☐ Oil Well ☒ Gas Well ☐ Other8. Well Name and No.
CARRACAS 19B 10-1ST

SRC would like to submit the attached updated plat for CARRACAS 19B #10-1ST.

WELL LOCATION AND ACREAGE DEDICATION PLAT

From: Connie Blaylock <cblaylock@mspartners.com>
Sent: Thursday, August 16, 2018 8:23 AM
To: Pickford, Katherine, EMNRD
Subject: RE: Plats with Proposed Lateral Path CARR 19B10-1ST

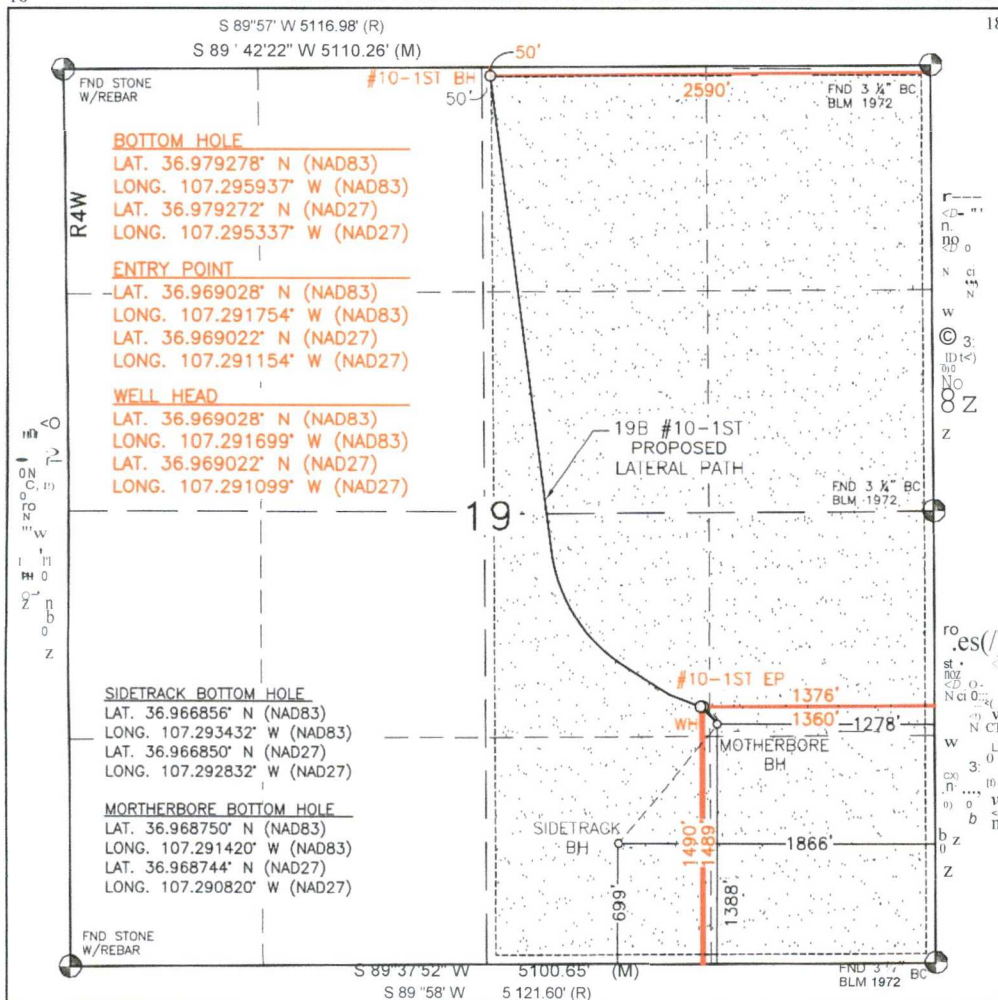
The footage calls on the surface location have changed from 1350' FEL and 1510' FSL to 1360' FEL and 1489' FSL.

Hi Connie,
I have received the new C-102s for these wells.
Can you explain why the surface hole location for the Carracas 19B 10 has changed so drastically since it was first drilled?
We have the SHL at 1510 FSL and 1350 FEL, as you show on your initial sundry for this work.
The new C-102, however shows 1489 FSL and 1360 FEL.
Also, be aware that these laterals will require NSLs, depending on how deep in measured depths your perfs go.
Thanks,
Kate

*My survey of **Section 19** and the footages from those Section Lines to the Well Head are accurate. I question the accuracy of a survey that shows footages to Section Lines that show no bearings along the Section Lines and the distances along the Section Lines are EXACTLY the same as platted by the GLO in 1907.*

It is my understanding that when the surveyor was sent to confirm surface locations, these are the measured section line distances to the wellhead. Because they did not exactly match what was on file with the old plats, we decided to submit

our most up-to-date surveys. I can't explain why the old numbers don't match the new numbers but the new numbers are what we plan to use to make sure we stay within our boundaries.
